AMENDMENTS TO DRAWINGS

REMARKS

The Office Action mailed December 18, 2006, has been carefully reviewed and the foregoing amendment has been made in response thereto. The amendments have been made to comply with the Office action and the examiner's requirements and to place the application in better condition for appeal.

Figure 2A

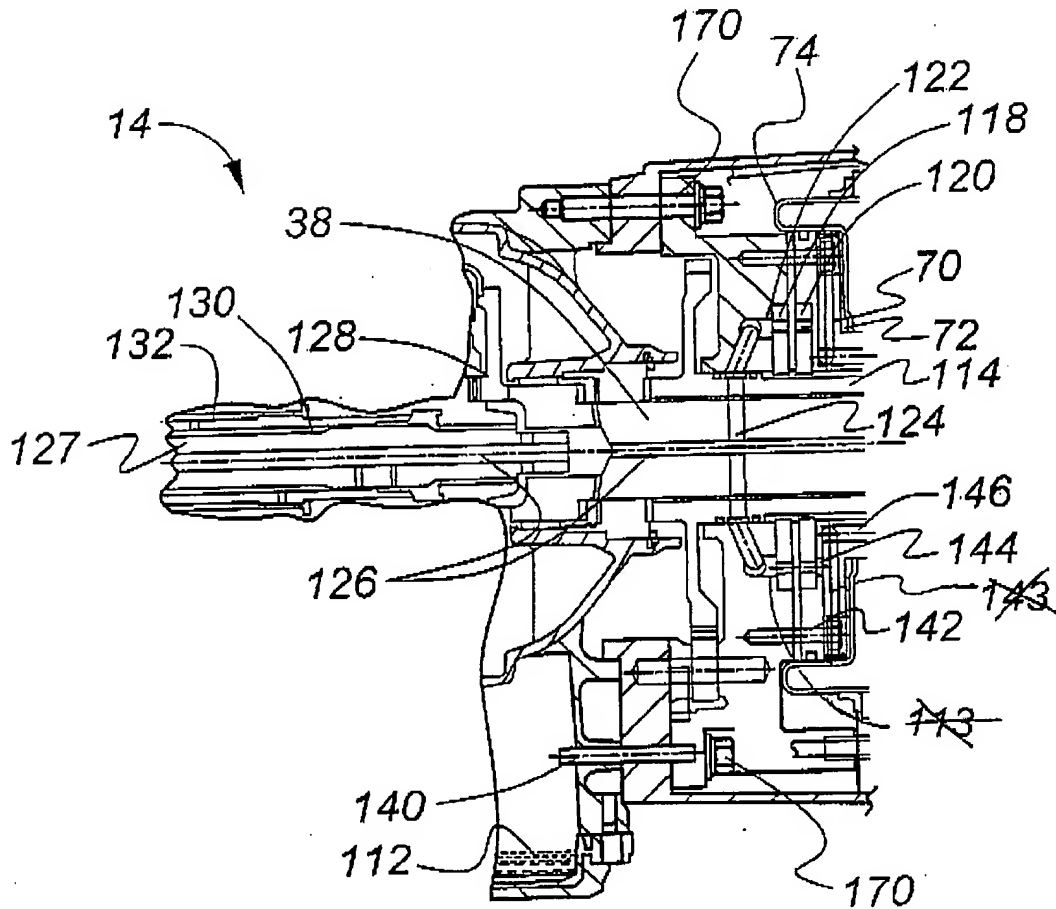
A Replacement Sheet for Page 2/3, Figure 2A, which is attached to this amendment, removes the changes of the prior amendment and restores Figure 2A to its condition when originally filed. Specifically reference numbers 113 and 143 have been removed from Figure 2A, thereby removing the inlet of scavenge pump 118 identified by reference number "113" and the radial passage, reference number "143."

An Annotated Sheets Showing Changes to Figure 2A on page 2/3 is enclosed. The amendment to the drawing enters no new matter; instead, it restores Figure 2A to its condition when originally filed.
